Project Millennium Application

Supplemental Information Response
1998

Supplemental Information Request
Suncor Millennium Project
EUB Application No. 980197, Registered 21 April 1998
EPEA Application No. 014-094, WRA File No. 27549/27551

**SUPPLEMENTAL INFORMATION
RESPONSE**

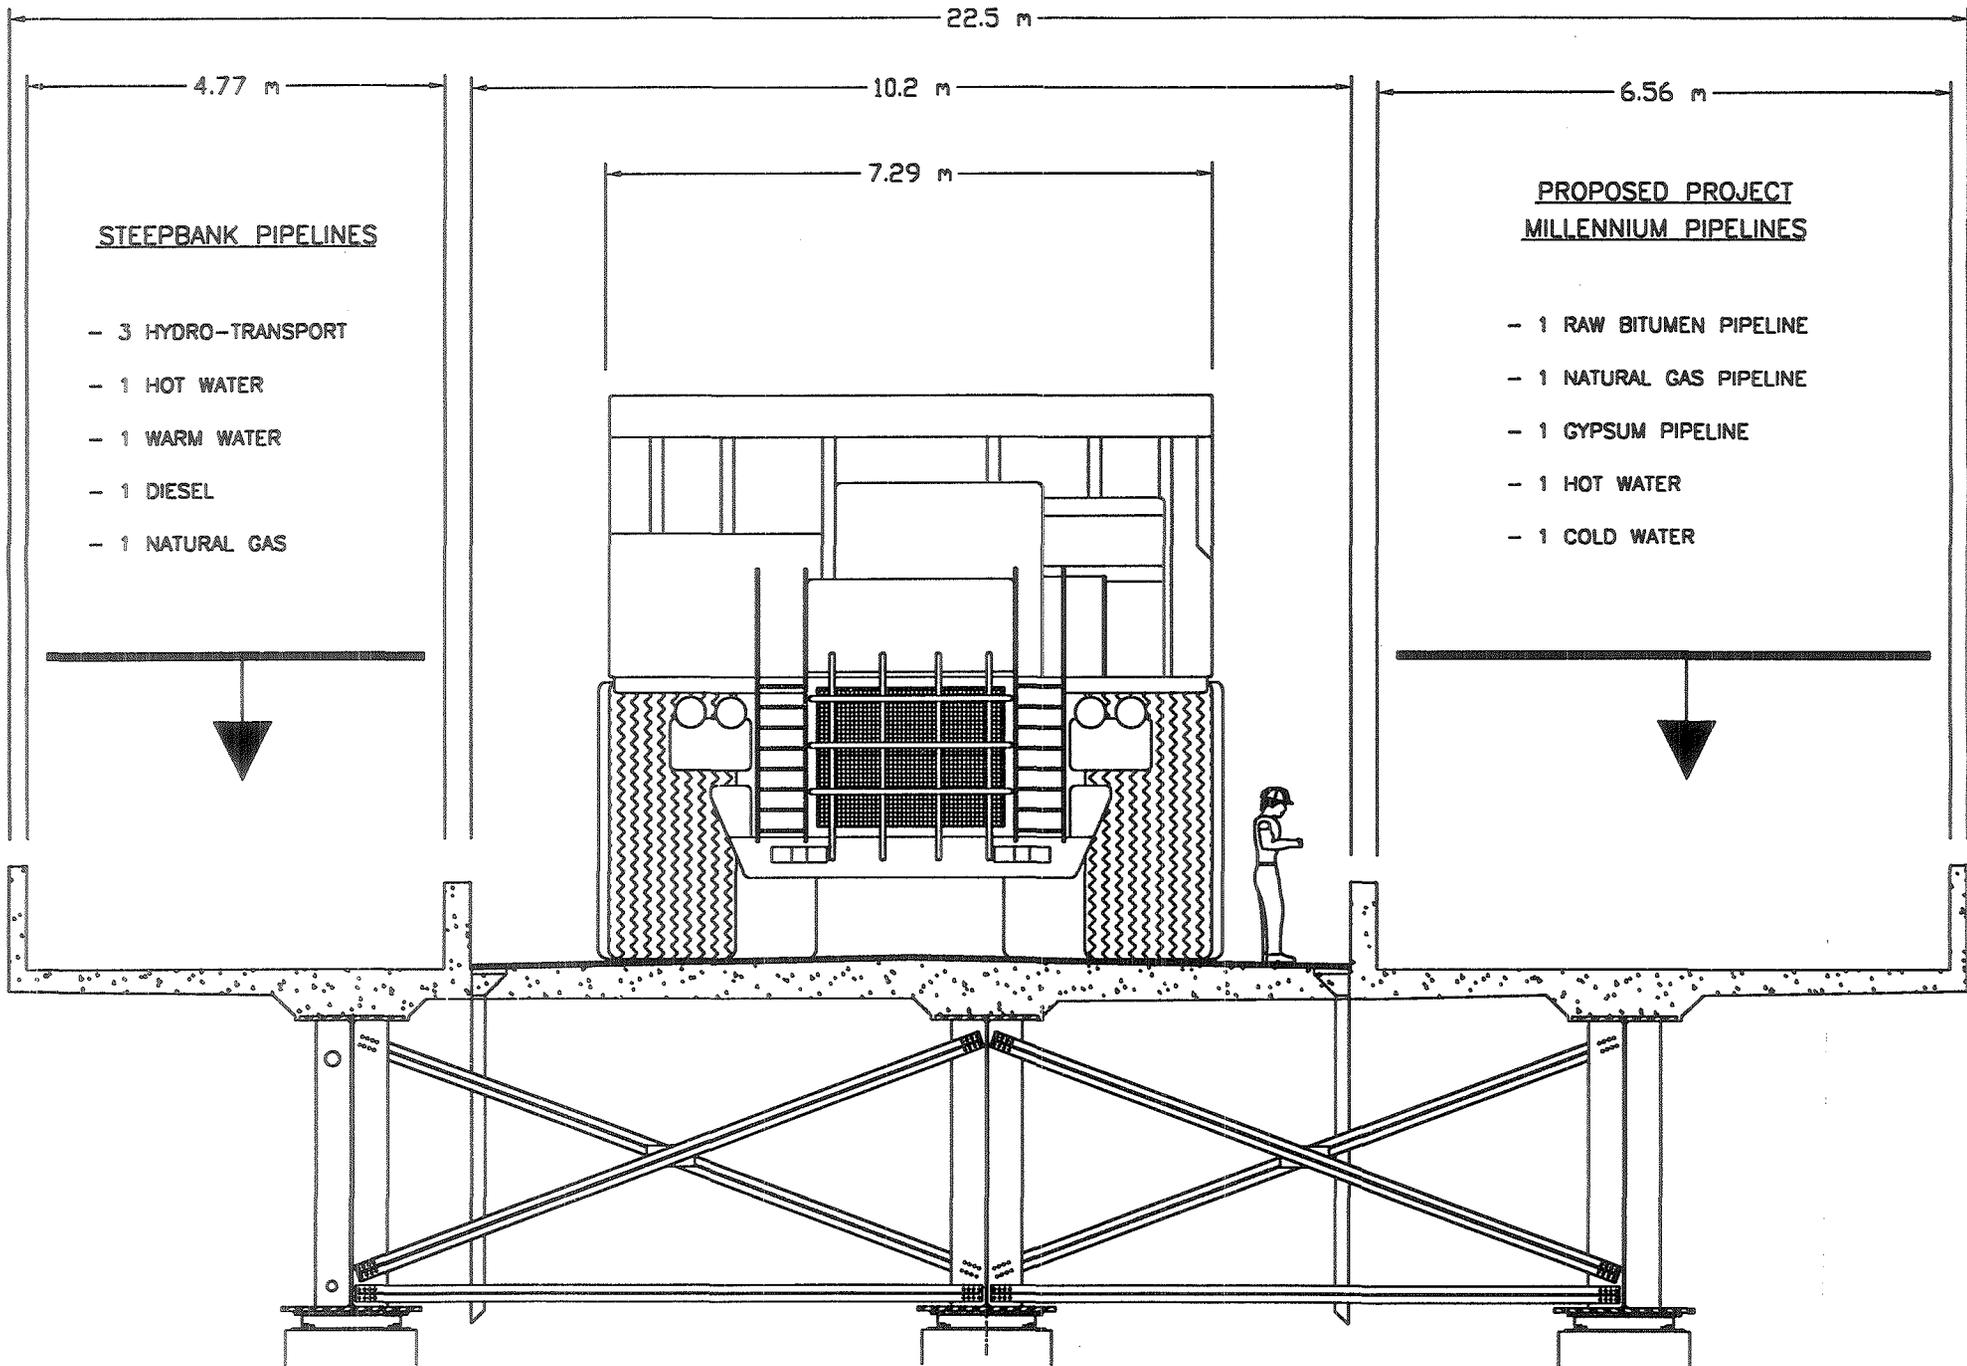
96. **Figure C4.0-5 of the Steepbank Mine Application shows the configuration of the pipelines on the Athabasca River Bridge. Update this information showing any additional pipelines that will be required for Project Millennium and the material to be transported in each line. Describe the ability of the bridge to handle any additional pipelines.**

The requested schematic is presented on the following page. There is sufficient ability to handle all contemplated pipeline needs

Figure B2-22 Predicted Baseline Potential Acid Input (PAI) in the RSA using the CALPUFF Model

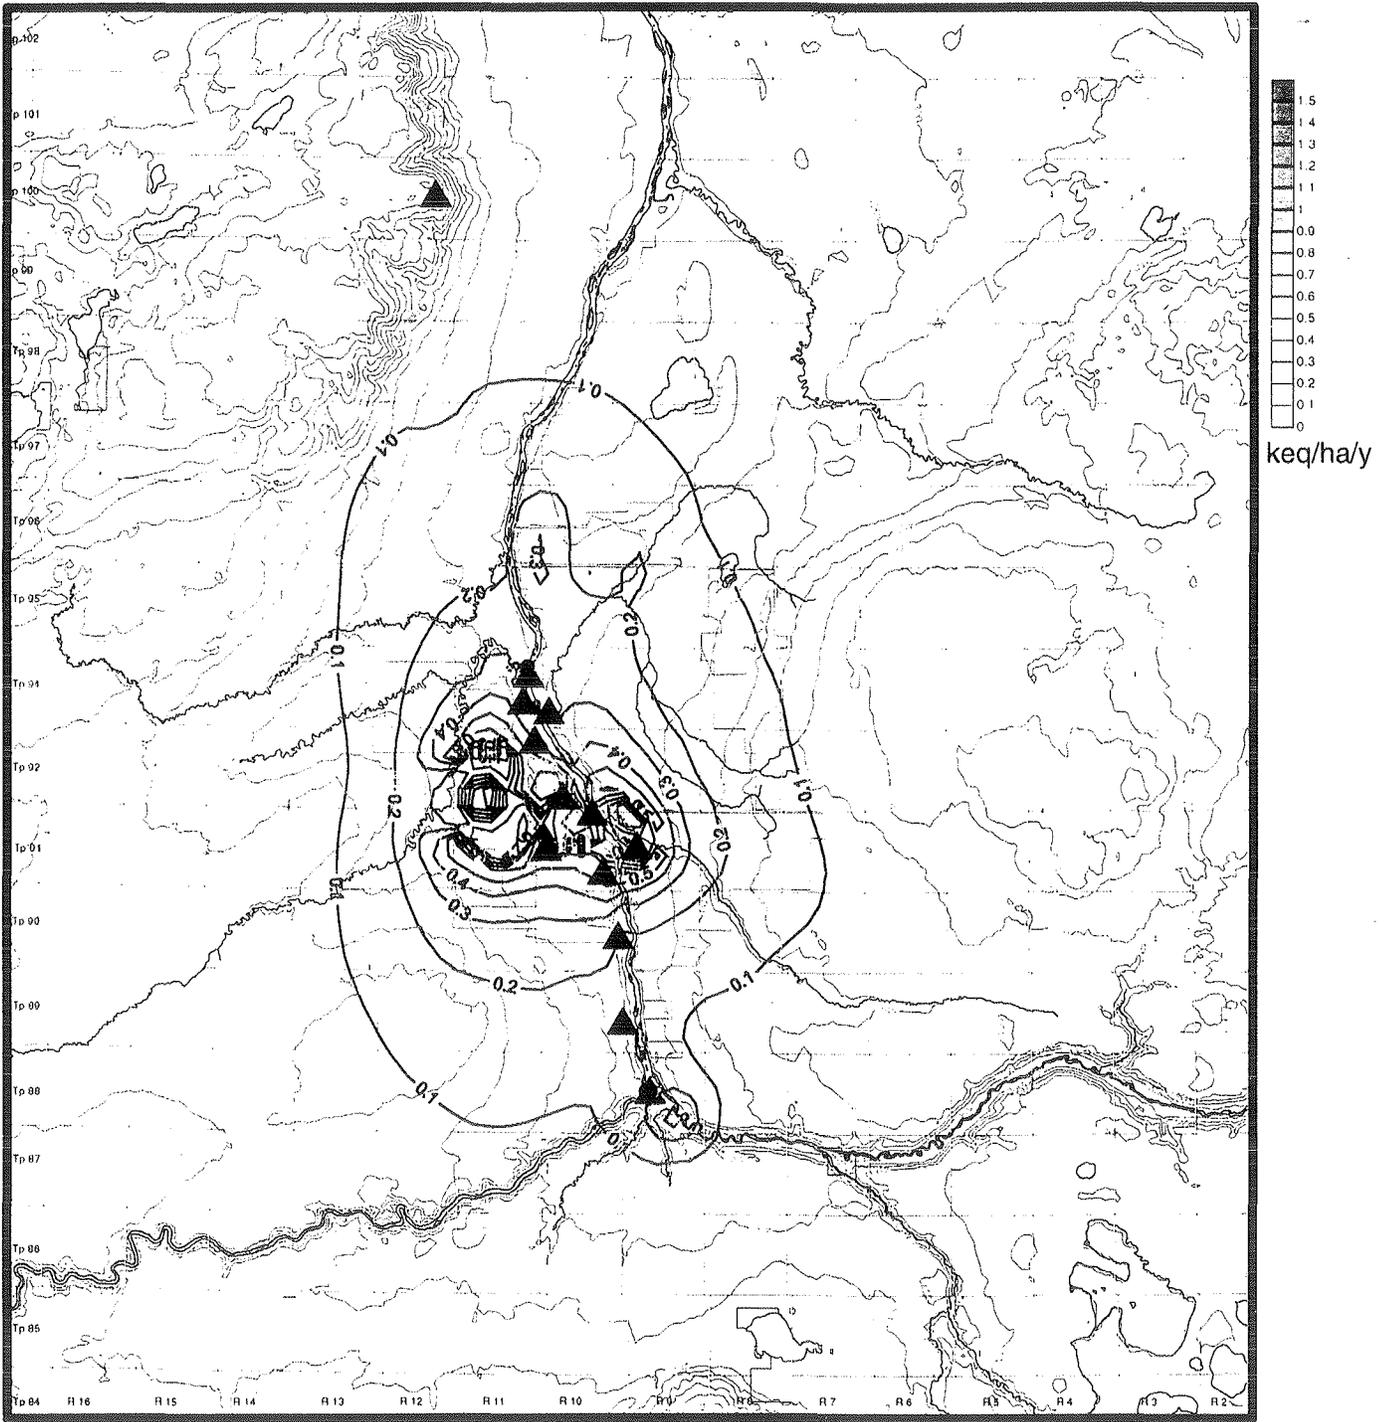
- h) Volume 2A Section B2.2.4, Figure B2-22 - In reference to the areal extent of lands exceeding 0.5 keq/ha/a a discrepancy exists with the data in Table B2 18. Figure B2-22 shows approximately 10 townships inside the 0.5 isopleth. This represents approximately 100,000 ha rather than the value of 11,543 ha contained in Table B2-18. Please confirm the correct value and modify any text in this section containing errors.**
